Appendix B – Peer Review

In response to a letter [Ref. 1] from the Chairman of the Advisory Committee on Reactor Safeguards (ACRS), the Executive Director for Operations (EDO) at the U.S. Nuclear Regulatory Commission (NRC) identified [Ref. 2] a need for conducting formal peer review of the developed technical basis for potential revision to PTS screening criteria in the PTS Rule (10 CFR 50.61).

The objective of the peer review was to perform a review to assess the adequacy and reasonableness of the developed technical basis (as detailed by the draft PTS NUREG report and other supporting documents) to support a potential revision of the PTS Rule (10 CFR 50.61).

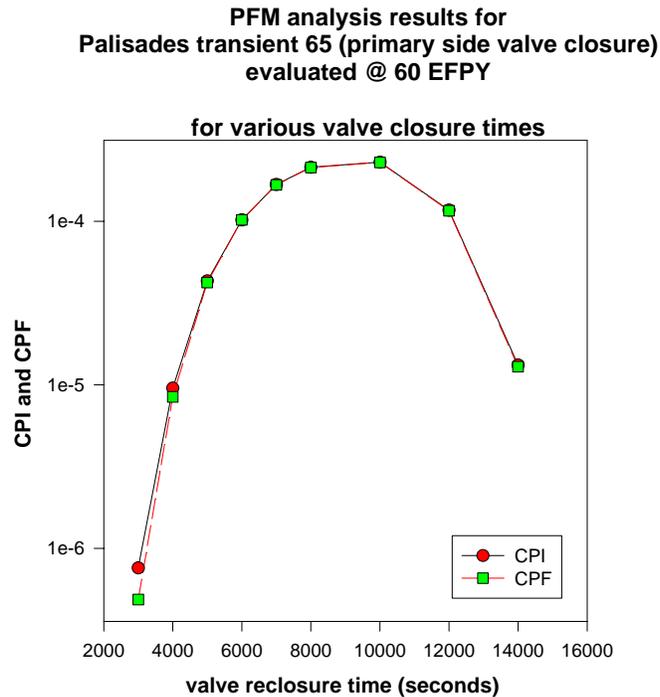
Comment: What is the justification for selecting only 3000 seconds and 6000 seconds as the only possible reclosure times for transients involving stuck-open safety valves? Why is this rather coarse discretization an adequate representation of the continuum of possible events?

Staff Response: As detailed in Section 8.5.3.2 of this report, valve reclosure is a random event that can occur at any time after the transient begins. In our model we have discretized this continuum into two possibilities: reclosure at 3000 and 6000 seconds. These possibilities were selected recognizing that the severity of the transient varies with valve reclosure time. Up to some time transient severity will increase with increasing time before reclosure because the temperature of the primary system is dropping (which reduces the fracture toughness), while the thermal stresses are still climbing (because the cool-down is continuing). However, once the RCS has reached its minimum temperature (established by the temperature of the HPI water) the severity of the event will begin to reduce because the thermal stresses will begin to decline. The 6000-second reclosure time was selected to (approximately) coincide with the time of maximum transient severity because it is at (approximately) this time that the RCS temperature is reaching its minimum value. The potential for valve reclosure after very long times (in excess of 7200 seconds, or 2 hours) were not considered because by that time operators would have initiated new procedures. Since the operator's objective is to stop the transient (stop dumping irradiated primary system water into containment) they would likely depressurize the steam generators by opening the steam dump valves to cool the secondary side, and they would start low-pressure injection so that they could shut off HPI. These actions change the nature of the transient, making it more benign. Also they change the probability of operator error. The 3000-second reclosure time was selected because it is not reasonable to assume that all valve reclosures will occur at the worst possible time.

Figure 1
Cooldown Transients for Palisades

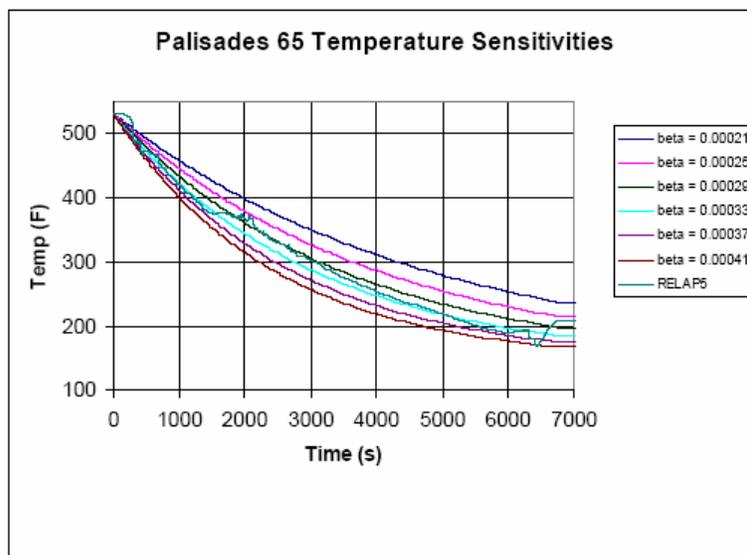
The cooldown rates examined are shown in Fig. 1, taken from the thermal-hydraulic sensitivity study by Bessette. The RELAP5 result was used as a basis and higher and lower values of the decay rate were obtained by using higher and lower values of b . This is a reasonable approach if the initial value calculated by RELAP5 is appropriate. The ranges of values of b chosen, however, yield less than a plus or minus 20% variation in the total downcomer temperature change. The ROSA tests show larger variations than this although it is not clear whether or not the average decay rate is higher or lower. Further, it is not clear how the figure was used; e.g., the given temperature time behavior is used for all the transients. This temperature range needs to be justified and how it is used needs to be explained.

How it was decided that the cooldown rate predicted by RELAP5 is the appropriate starting place is not clear. It seems that this would be a good place to use the results from the OSU testing as it was based on scaled studies. Doing so would give a “code independent” evaluation as well as an opportunity to further validate the code. An initial step might be to incorporate some of the OSU scaling study results (NUREG/CR-6731) into Figure 1.
